Development Control Plan 2014 – Amendment

Oakdale South Industrial Estate (OSE)

Proposed Road Patterns

Figure D2.16: Proposed road pattern for Acorn Street in the vicinity of Grey Street, Emu Plains

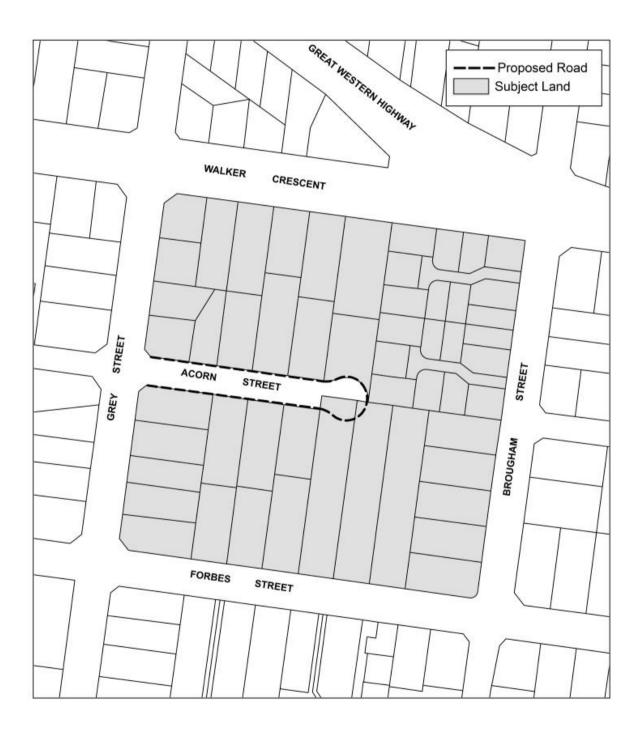
Development patterns shall be consistent with the road patterns as shown in Figures D2.15 to D2.18:
